**LEXINGTON-FAYETTE URBAN COUNTY
 GOVERNMENT CONTRACT CHANGE ORDER**
 Page 1 of 2

Date:	January 19, 2017
Project:	Investigation/Design Services for Town Branch WWTP Primary Digester Complex Improvements
Location:	Town Branch WWTP

CHANGE ORDER: 1

Re: Town Branch Primary Digester Complex Improvements

1 PLAN - MEZZANINE FLOOR COMPRESSOR ROOM
ELEV. 909.50

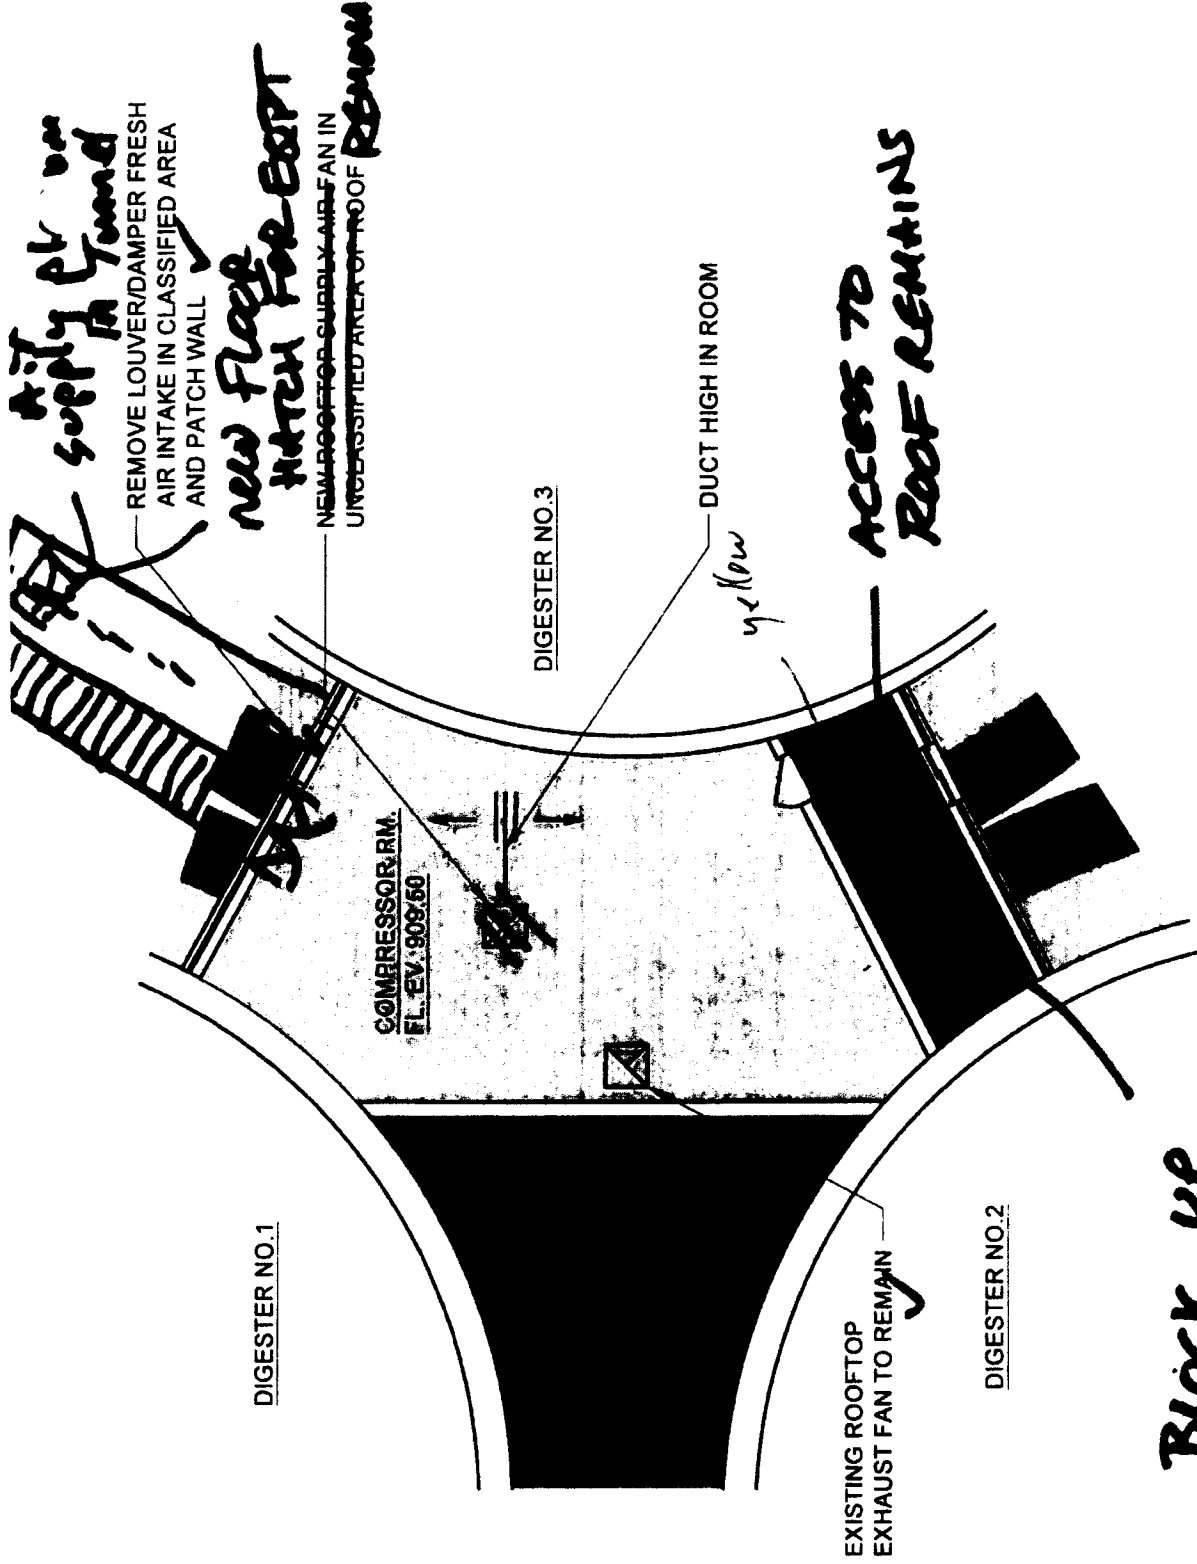
**Block up
STAIRWELL FLOOR
TO SEPARATE SPACES**

1 PLAN - OPERATING FLOOR
 ELEV. 897.50

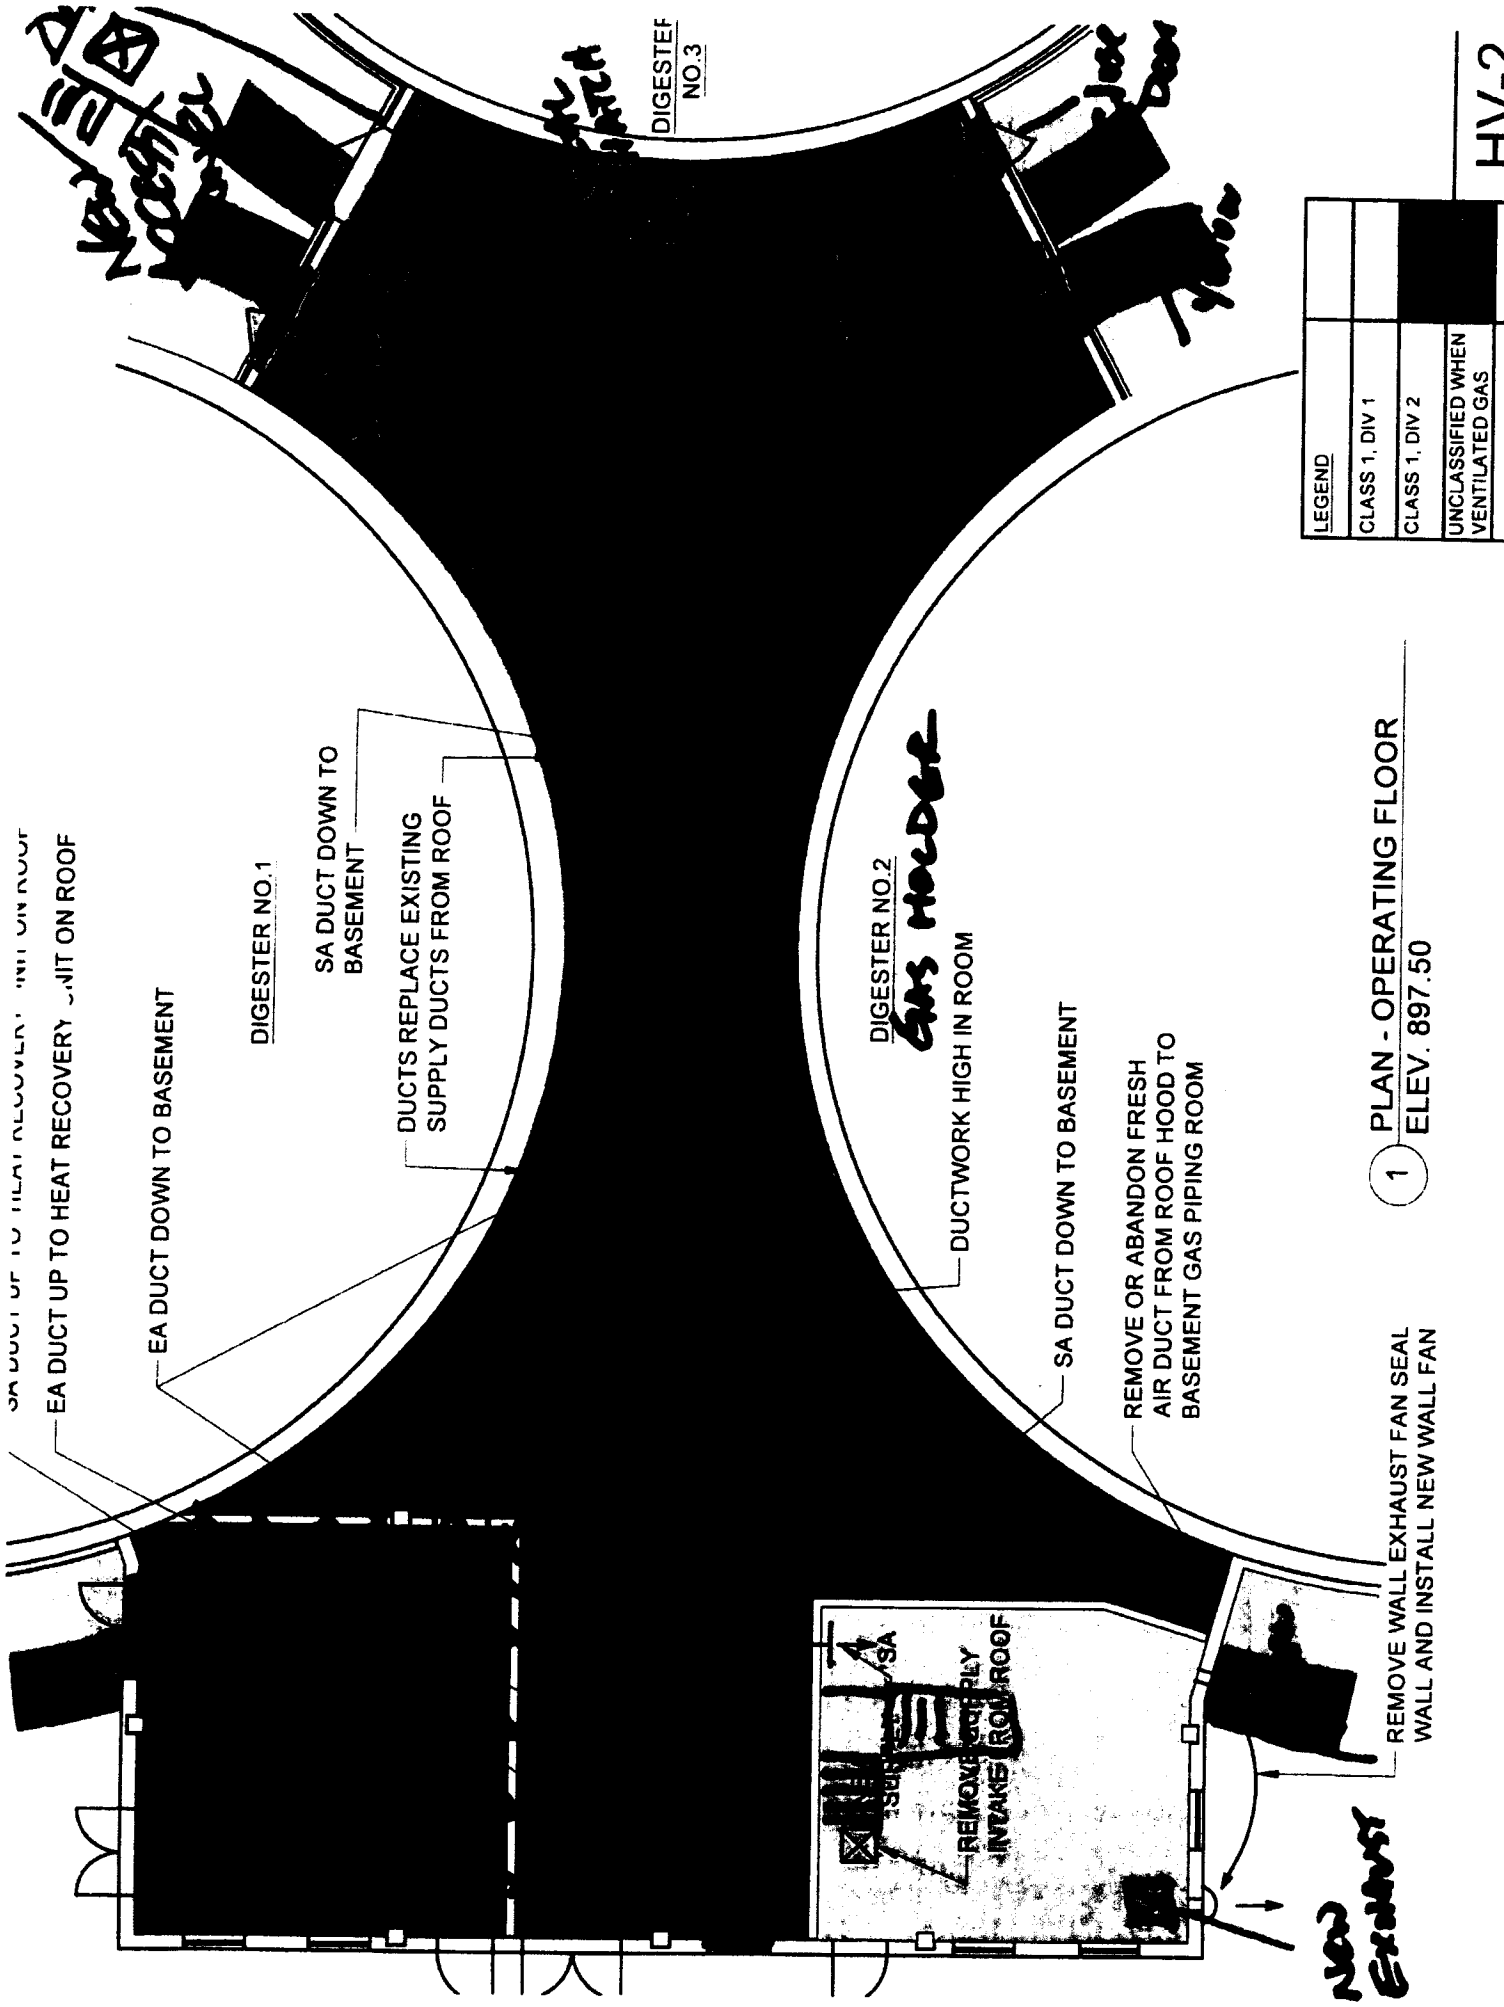
SA DUCT UP TO HEAT RECOVERY UNIT ON ROOF
 EA DUCT UP TO HEAT RECOVERY UNIT ON ROOF

EA DUCT DOWN TO BASEMENT

SA DUCT DOWN TO BASEMENT

DUCTS REPLACE EXISTING SUPPLY DUCTS FROM ROOF

DUCTWORK HIGH IN ROOM

SA DUCT DOWN TO BASEMENT

REMOVE OR ABANDON FRESH AIR DUCT FROM ROOF HOOD TO BASEMENT GAS PIPING ROOM

REMOVE WALL EXHAUST FAN SEAL WALL AND INSTALL NEW WALL FAN
